Addendum

SPRINGS AT FREMAUX TOWN CENTER
SLIDELL, LA

DRAWING TITLE FIRST FLOOR PLAN - CLUBHOUSE

1 FIRST FLOOR ELECTRICAL PLAN - CLUBHOUSE
SCALE: 1/4" = 1'-0"

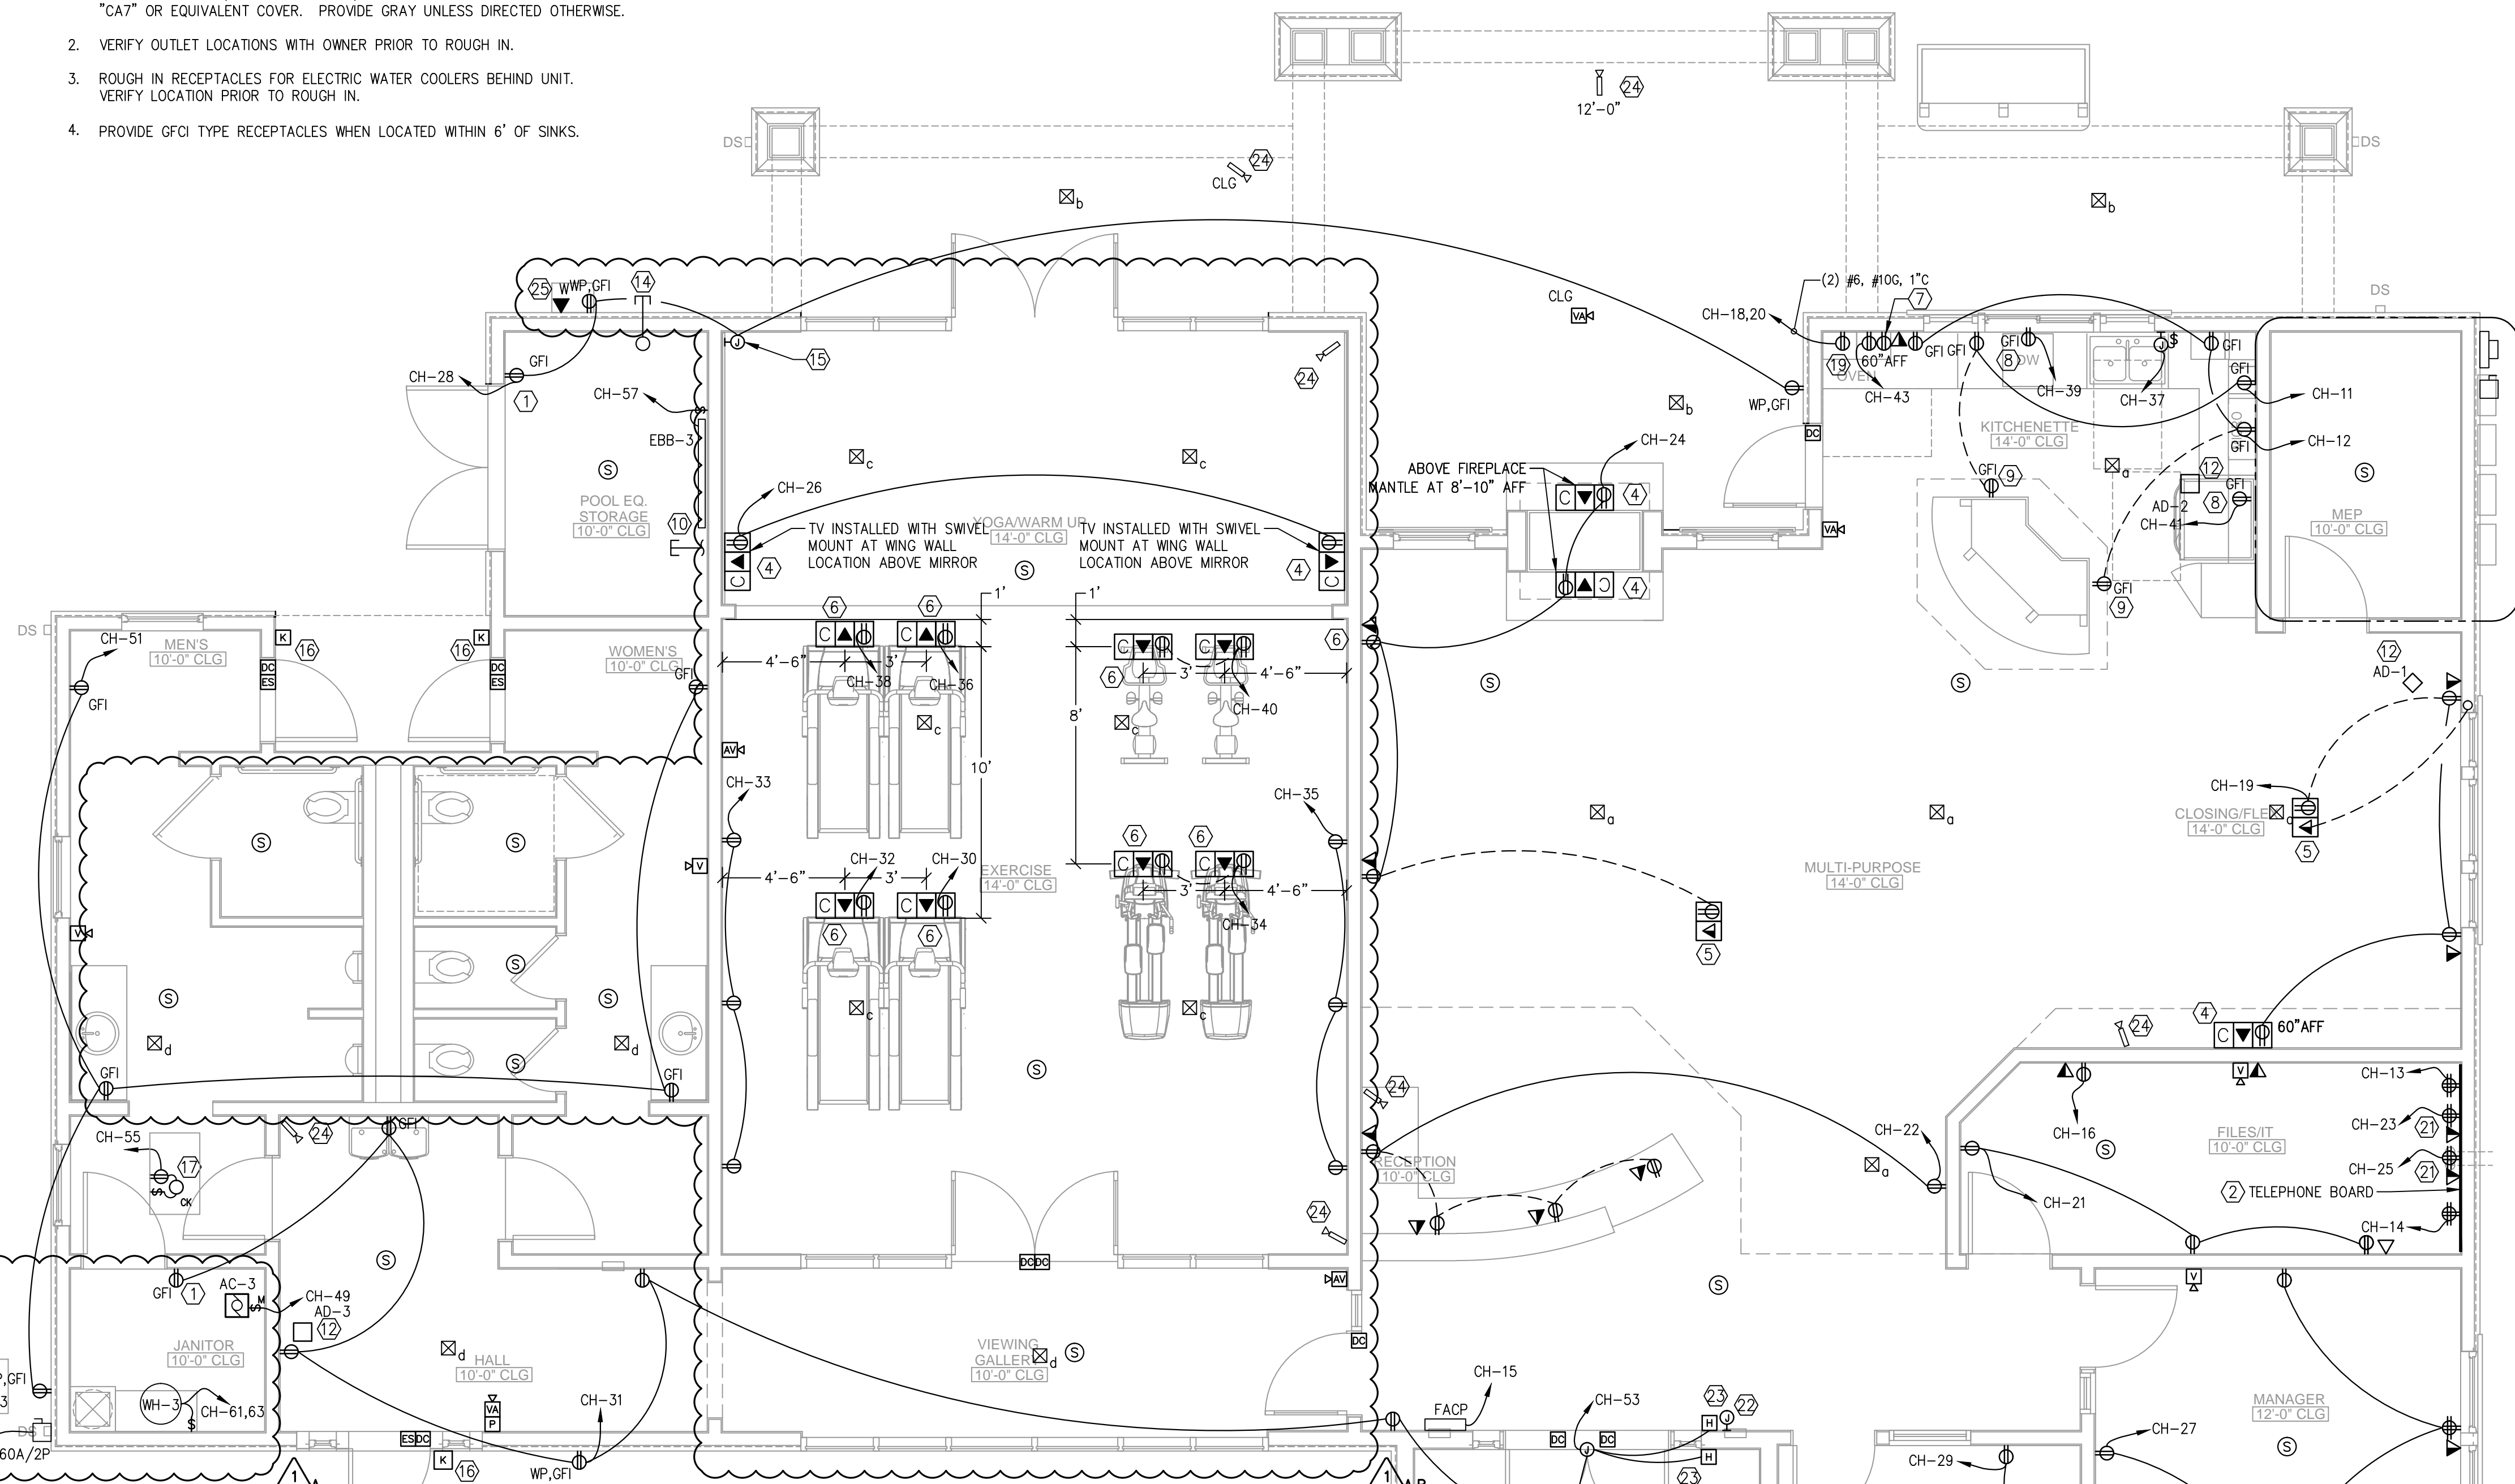
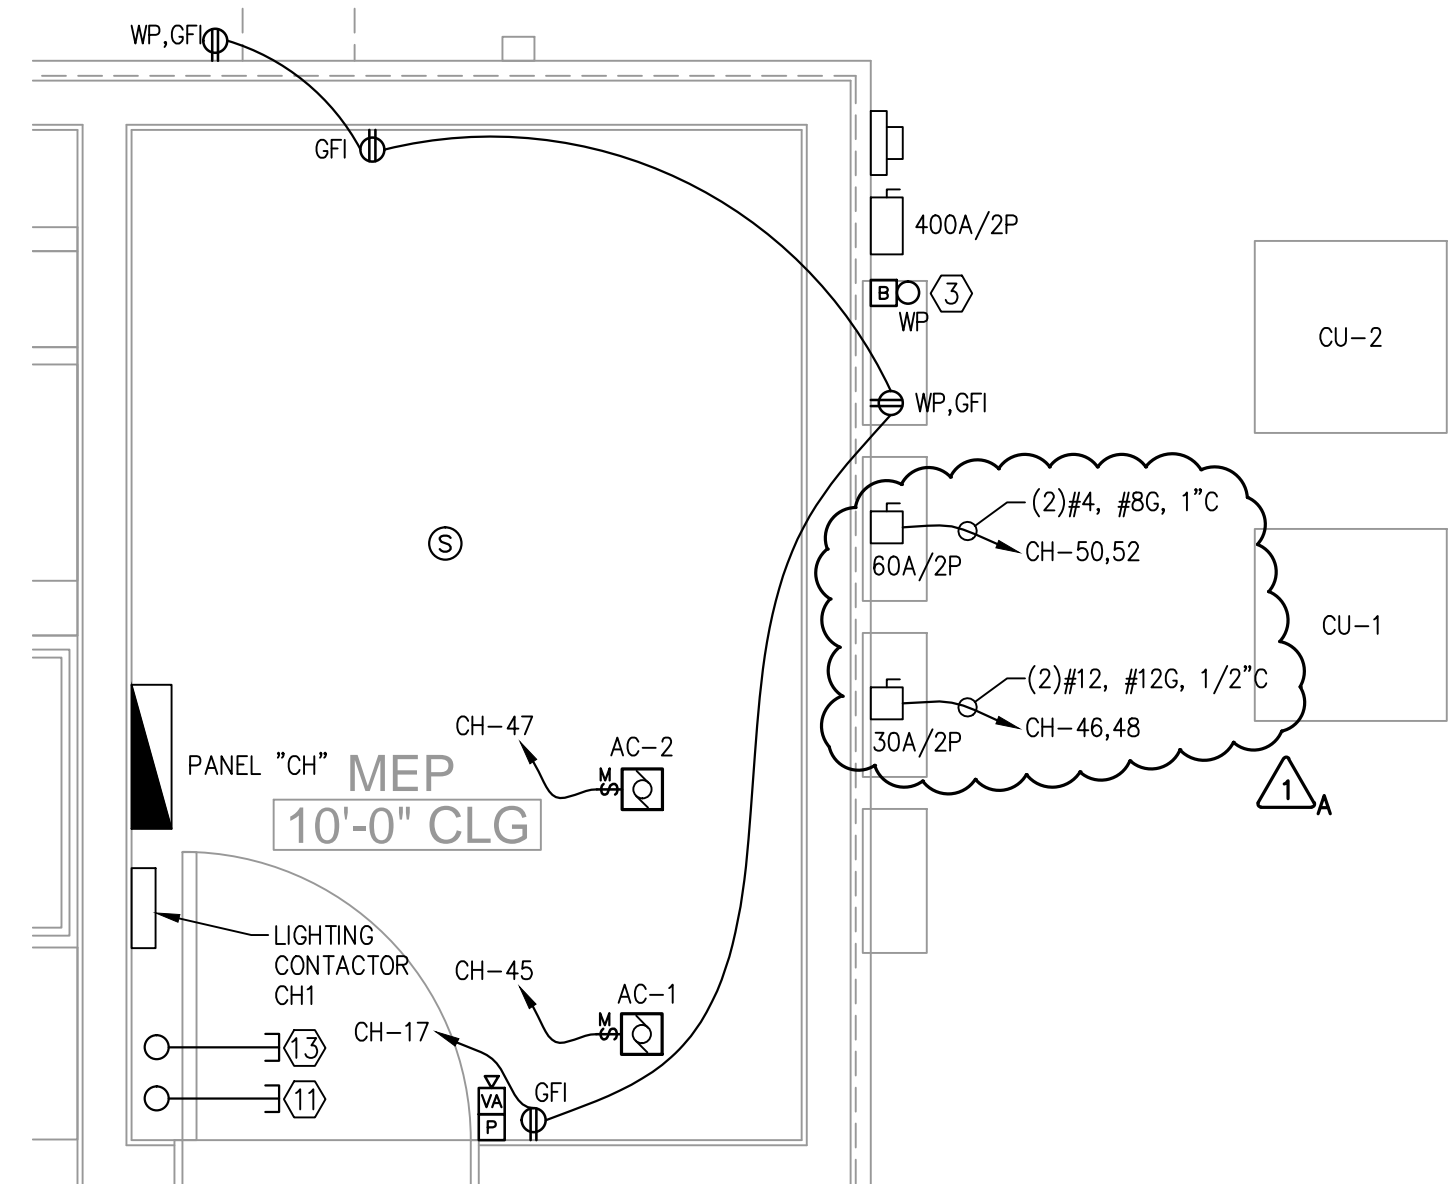
- UPDATED HVAC/PLUMBING EQUIPMENT
- UPDATED EXERCISE/YOGA PER ARCH CHANGES

1 FIRST FLOOR LIGHTING PLAN - CLUBHOUSE
E2.C.11 SCALE: 1/4" = 1'-0"

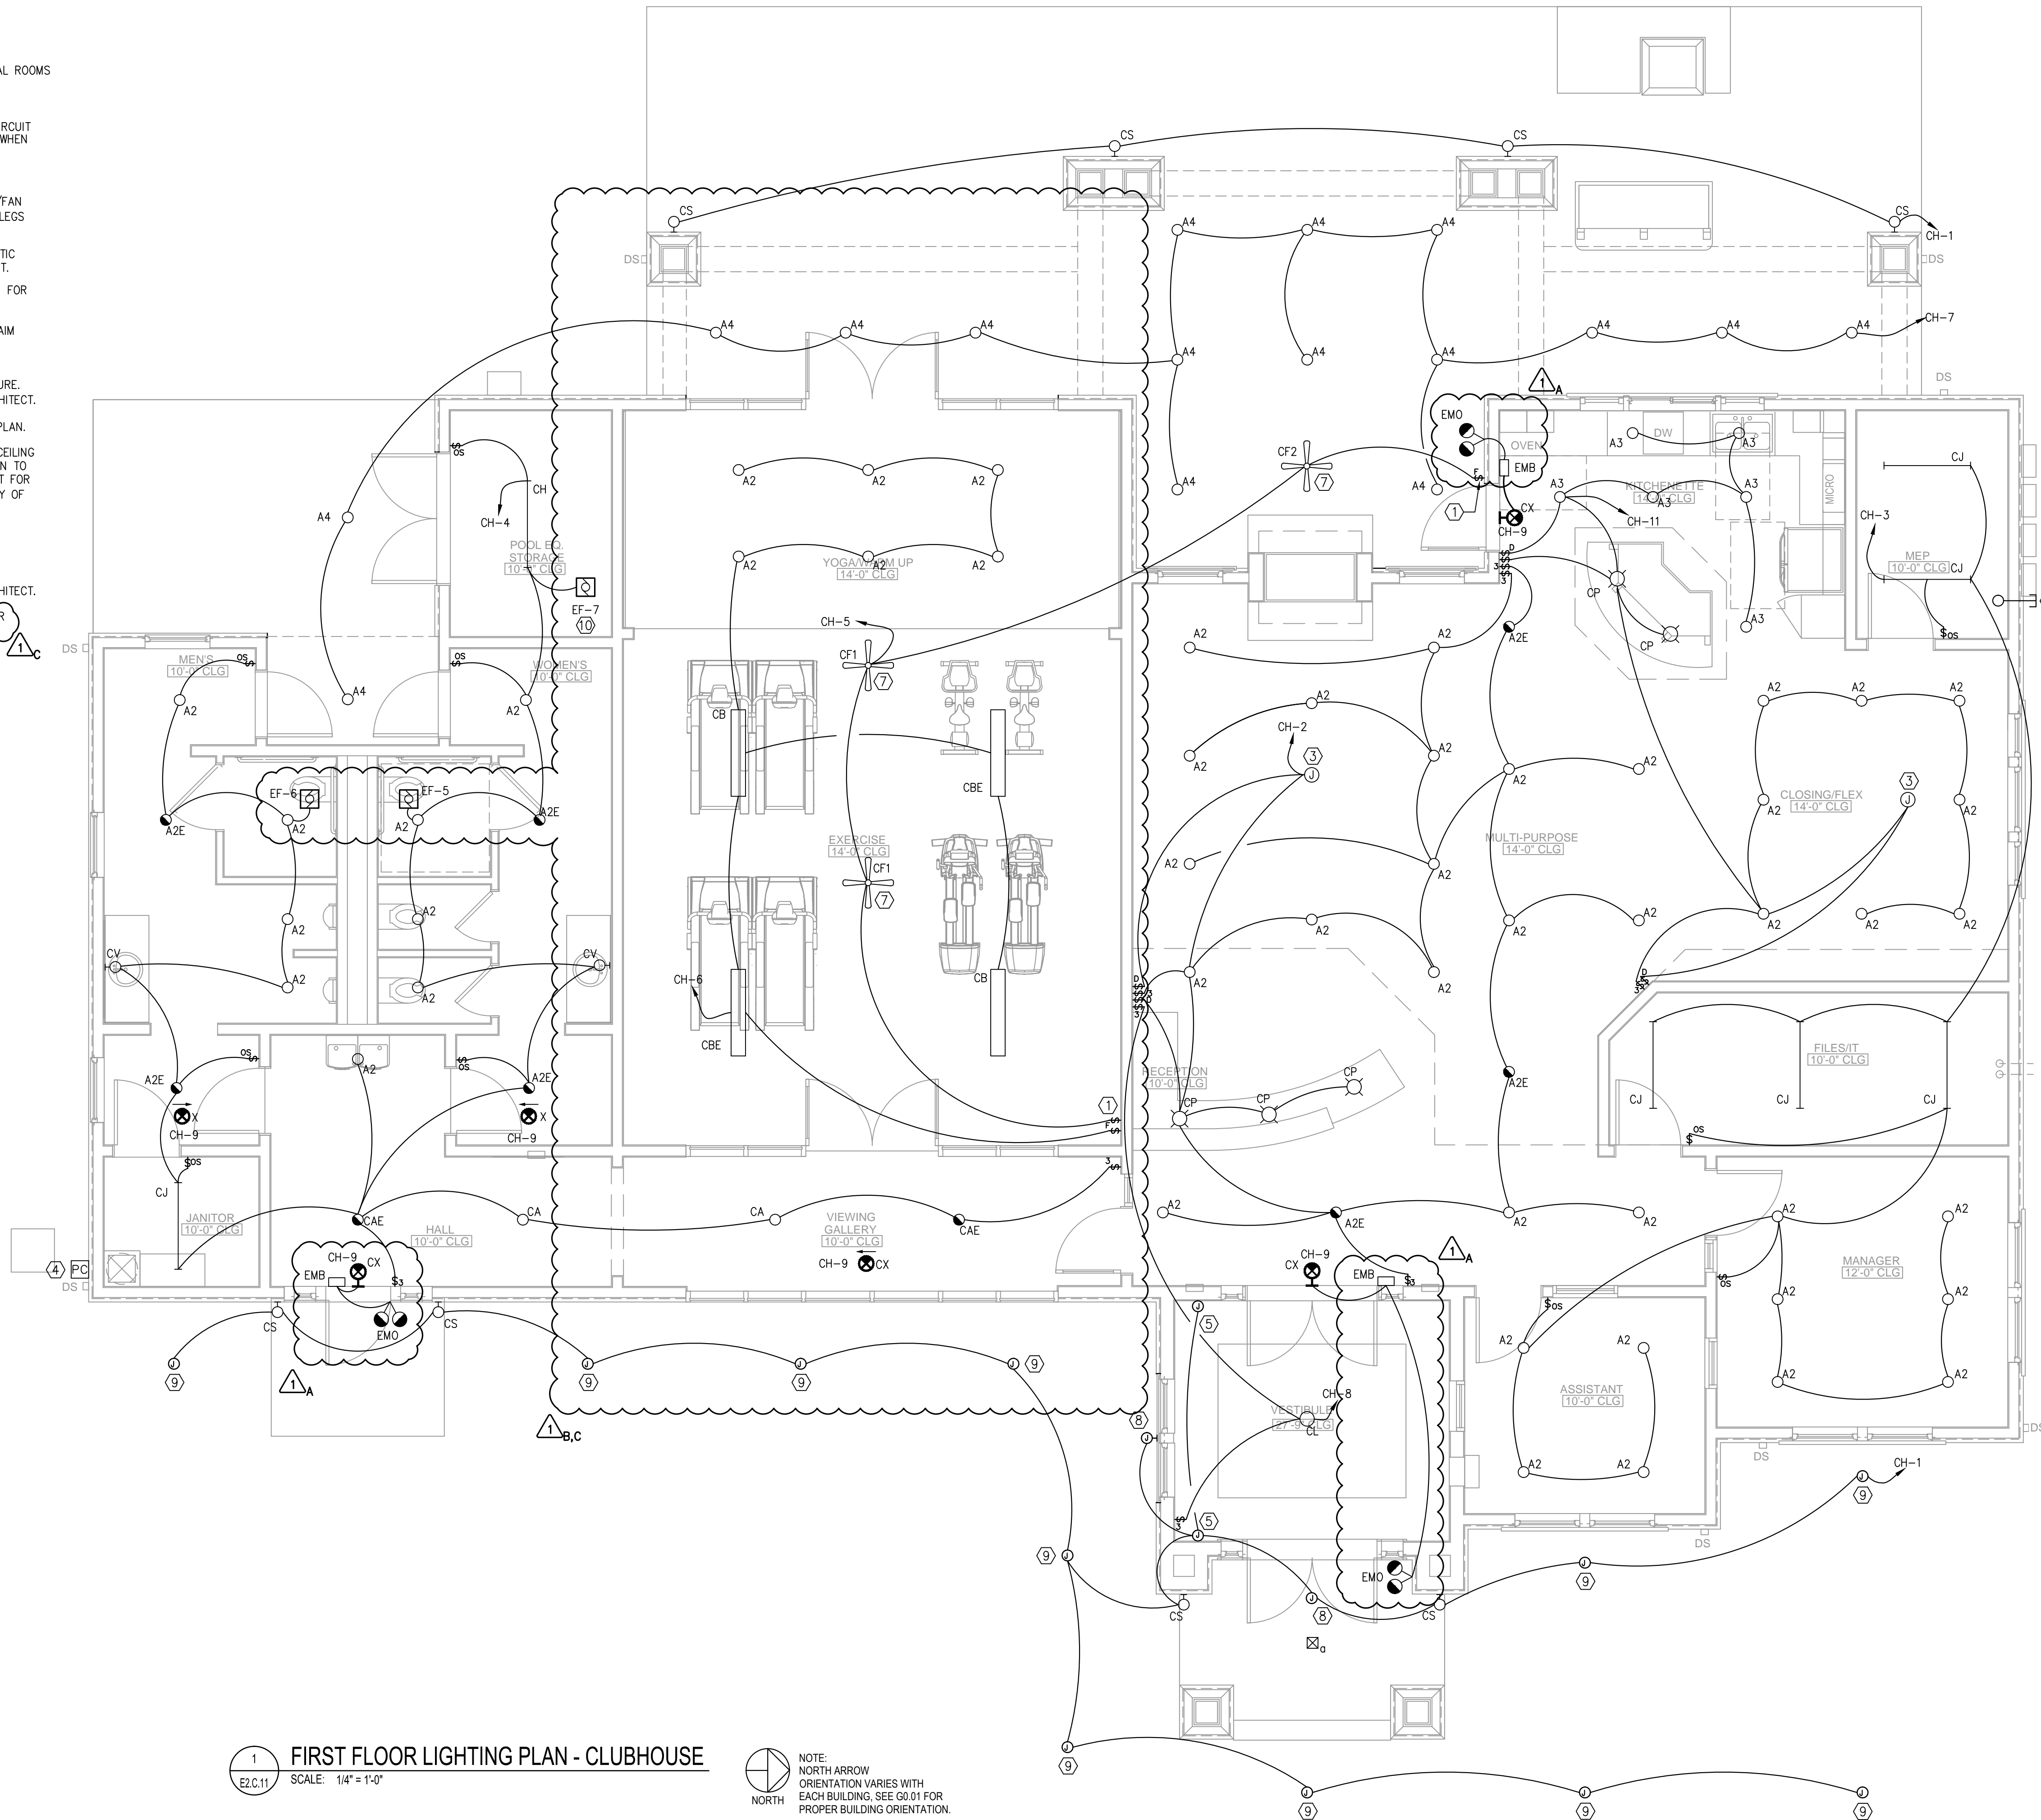
- A. UPDATED EMERGENCY LIGHTS
- B. UPDATED EXERCISE/YOGA PER ARCH CHANGES
- C. UPDATED HVAC EQUIPMENT
